TAL-CO SUPPLEMENTAL INSTRUCTION #24			
Project Name:	RW TOMLINSON - NEW HEAD OFFICE		
Project Location:	100 City Gate Drive, Ottawa, Ontario		
ARCH. SI #:	ASK # 54, 56, 57	Issued By:	Chris Simpson
STRUC. SI #:	N/A	Date Issued:	December 21, 2016
MECH. SI #:	N/A	Revision #:	N/A
ELEC. SI #:	N/A	Revision Date:	N/A

**Title:** Typical location of water bottle filling stations.

**Reference:** Architectural - Issued for Construction Drawings dated 11-Nov-16

DATE: 2016/12/02  
 SCALE: N/A  
 DRAWN BY: JK  
 JOB No: 574-15  
 DRAWING No:  
**ASK-54**

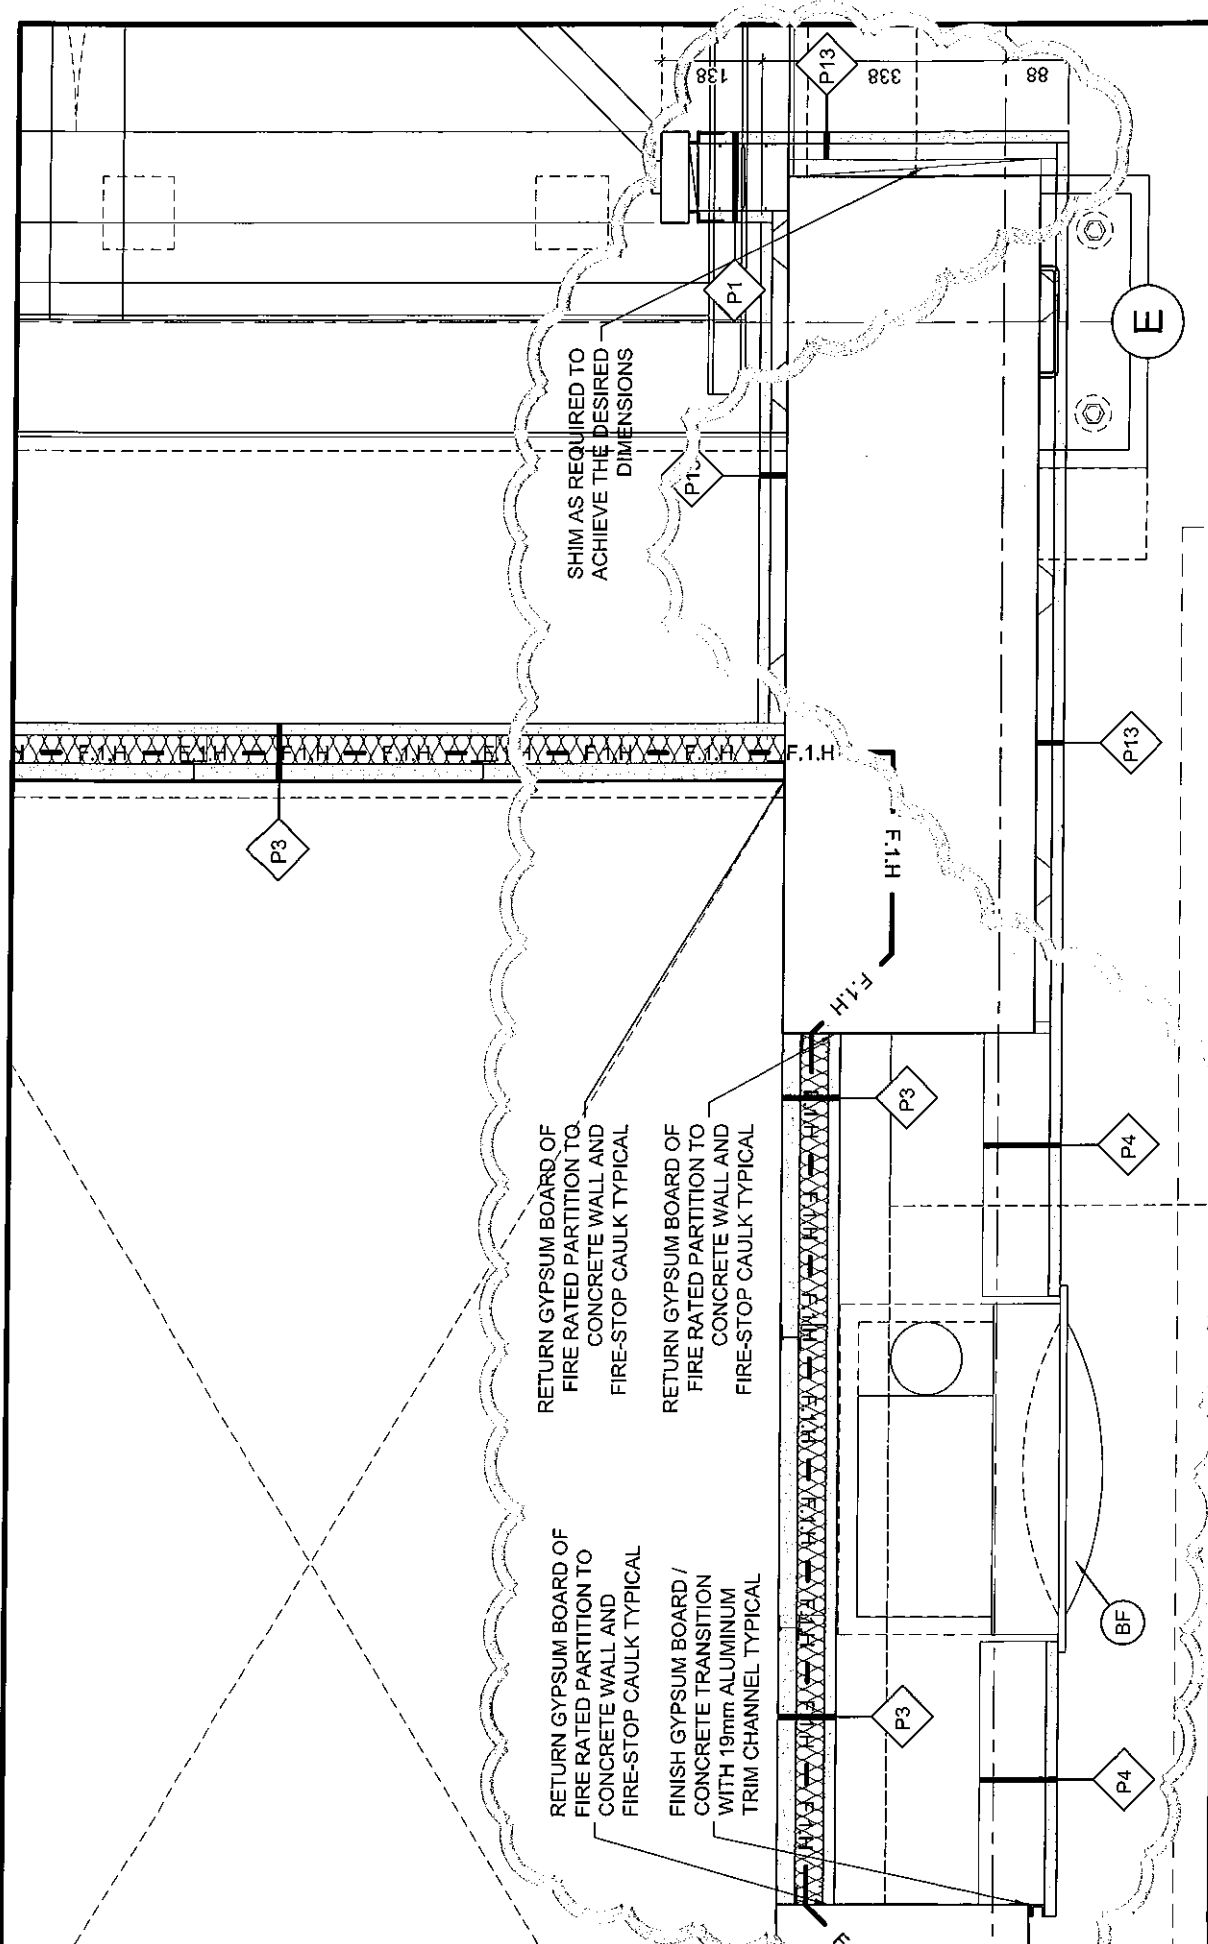
**Reason:** Typical locations of water bottle filling stations to be coordinated with mechanical.
